City of Mississauga Department Comments

Date Finalized: 2022-02-16 File(s): A114.22
Ward 3

The applicant requests the Committee to approve a minor variance to allow an existing carport with:

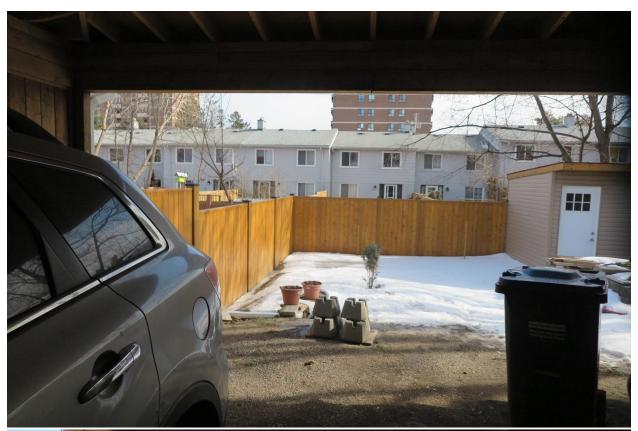
Enclosed for Committee's information are a number of photos which depict the constructed carport, rear porch addition, and accessory structure in the rear yard (not included in the variances requested, however encroaches into a bell easement and appears not comply with zoning setbacks). From the photos, it is evident that the hard surface area has been significantly increased on this property. The topography of this lot is such that all the drainage from the carport and rear porch is directed towards the rear yard. We checked the Grading Plan approved for the Forest Glen Subdivision (Road Grades & Lot Elevations Plan C-6824 dated Dec 1963) and note that for this lot the drainage was designed to be directed to the rear yard and then towards the abutting lot to the east (#3432 Bannerhill Ave.).

With regards to the accessory structure in the rear yard, we note that it has been constructed within the limits of what we believe is a Bell Canada Easement. It should also be noted that variances may be required as from our site inspection we noted that the structure was constructed abutting both the side and rear yard fence with no setbacks. With regards to the encroachment within an easement, the owner will be required to relocate the structure or alternatively obtain the approvals from the appropriate utility company for the encroachment.

According to the Grading Plan reviewed, the accessory structure may also be impeding drainage from the abutting property to the west (3440 Bannerhill Ave.) as drainage from this property was designed to be directed across the subject property and be directed to the east.

In view of the above noted concerns, we would request that the application be deferred pending additional information being provided, the accessory structure possible variances be addressed and perhaps some feedback from the abutting property owners would be provided which would assist in identifying any significant drainage concerns. The applicant in the resubmission for the next hearing should also consider the removal of some of the roof structure(s) to lessen the drainage runoff from this property.
